High Desert Corridor Project

Final Environmental Impact Report/
Environmental Impact Statement
and Section 4(f) (De Minimis Findings)

Volume 3 of 3

June 2016

Figure 2
Palmdale Alignment Alternative and Transportation Center Station Option
from May 2014 Supplemental Alternatives Analysis

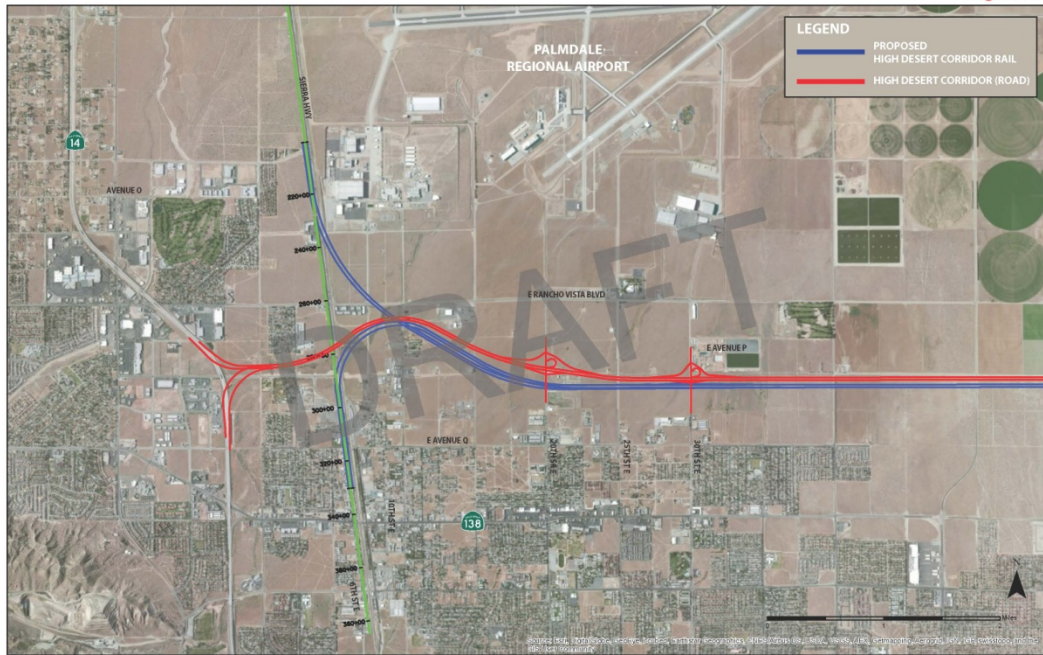
The Authority would prefer a high-speed rail connection option that does not require the HDC Project rail connectors to go under the existing railroad tracks and be below ground in a bored tunnel or a cut and cover box. Recognizing that Caltrans does not want the highway element of the HDC Project to go under the existing railroad tracks, the Authority has developed a high-speed rail connection option that would allow for both the rail and highway elements of the HDC Project to pass over the existing railroad tracks. This configuration is shown in Figure 3. The Authority respectfully requests that this configuration option be added to the alternatives that will be studied in the Final EIR/EIS.

S-5-4 (Design)	Figures 2-3 to 2-8 in the Final EIR/EIS have been developed to show possible locations for a joint HSR-HDC platform. These locations were developed based on discussions with the CHSRA and with the understanding that the Authority’s platform location is still subject to change and that this location of any joint platform must be mutually beneficial to both the HSR and HDC projects.
S-5-5 (Design)	Figures 2-3 to 2-8 in the Draft EIR/EIS were revised to clarify that the tunnel and aerial segments refer to the HDC and not the California HSR project.
